**Advisory Action
Before the Filing of an Appeal Brief**

10/665,680

GALLUP ET AL.

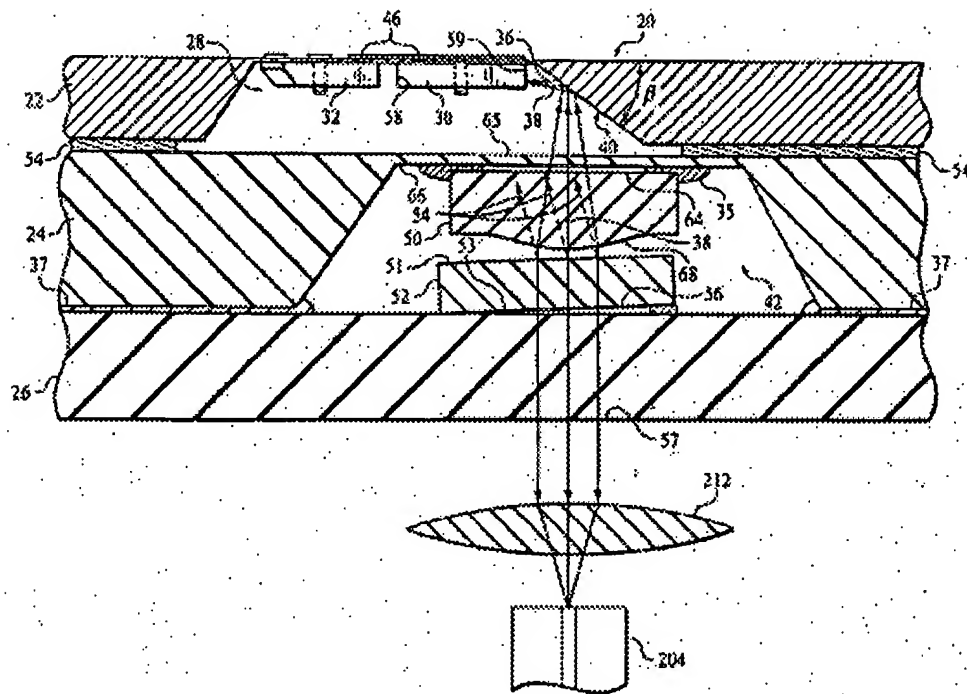
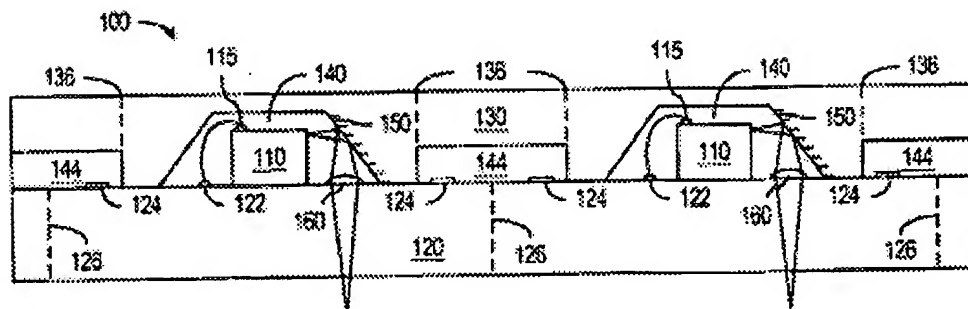
Continuation of 11. does NOT place the application in condition for allowance because: With all due respect, the exposed trace is taught in paragraph [0026] as the "metalization within the recess and not the hermetically sealed feed through connections (46). Since applicant chooses to not show the conductive traces (Specification Para [0025] page 5) in the disclosed figures, then examiner respectfully request applicant to explicitly show where the conductive traces are in applicant's disclosure and how Killian's disclosure of the metalization within the recess fails to meet the instant limitation. Regarding applicant's argument of the light not passing through the sub-mount is a matter of lexicography. If applicant contends otherwise, examiner respectfully request an analysis of applicant's invention is conceptually different from Killian in a side-by-side figures comparison, attached herein. .
